UNITED STATES PATENT AND TRADEMARK OFFICE

APPLICATION NO.	FILING DATE	FIRST NAMED INVENTOR	ATTORNEY DOCKET NO.	CONFIRMATION NO.
10/771,722	02/04/2004	Fritz Leber	ZAHFRI P592US	4959
20210	7590	07/15/2005		
			EXAMINER	
			BONCK, RODNEY H	
			ART UNIT	PAPER NUMBER
			3681

DETAILED ACTION

Fig. 2

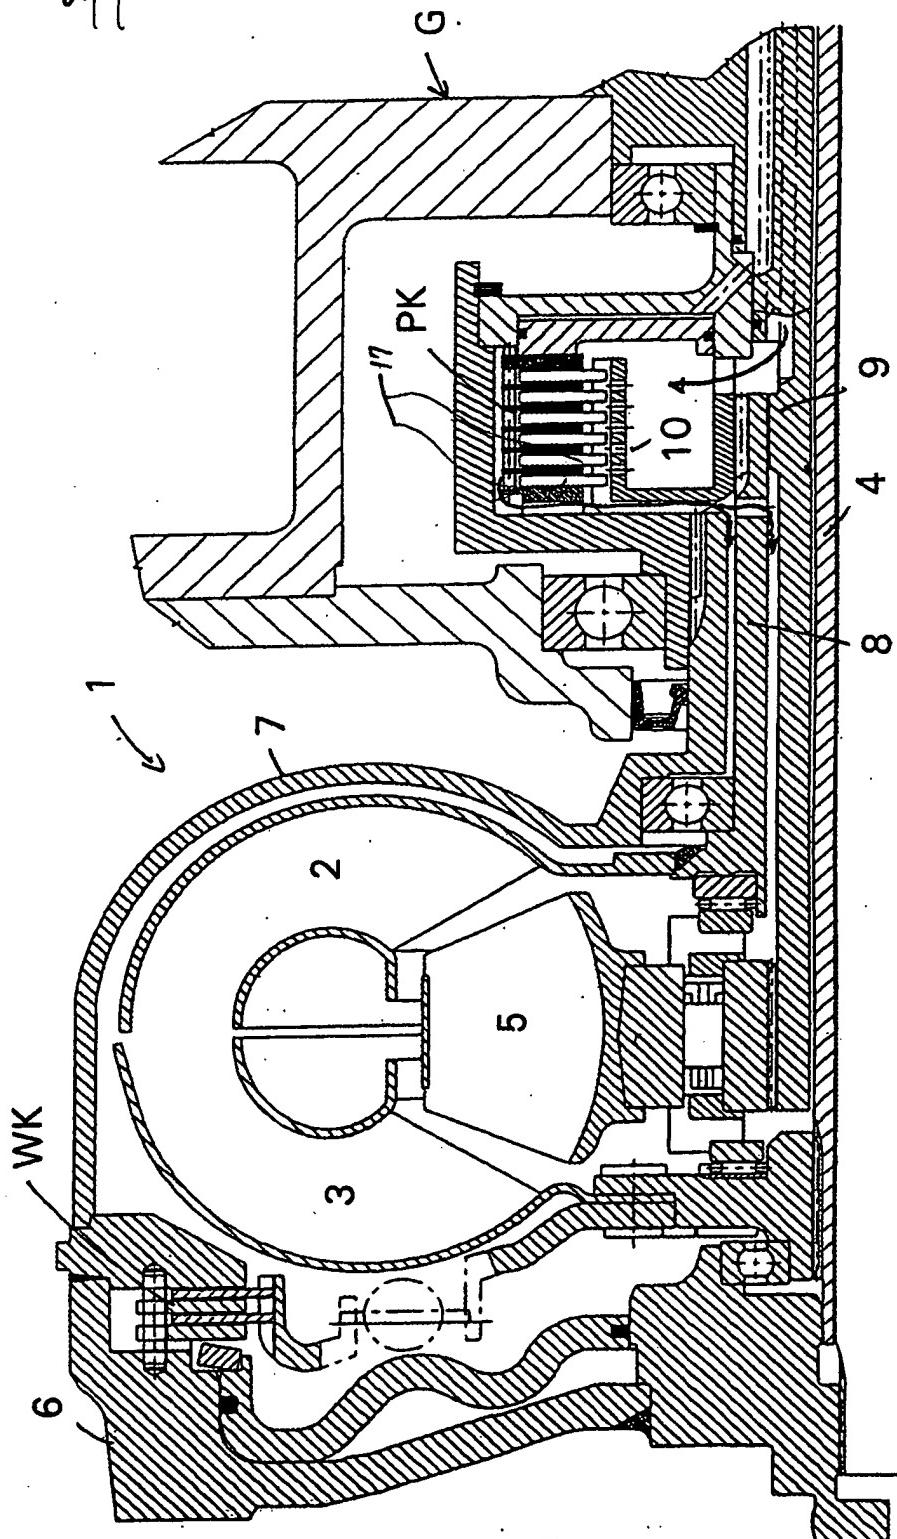
The proposed drawing correction was received on May 31, 2005. The proposed change is approved.

Annotated Marked-Up Drawing

Approved
JHEB
07/16/05
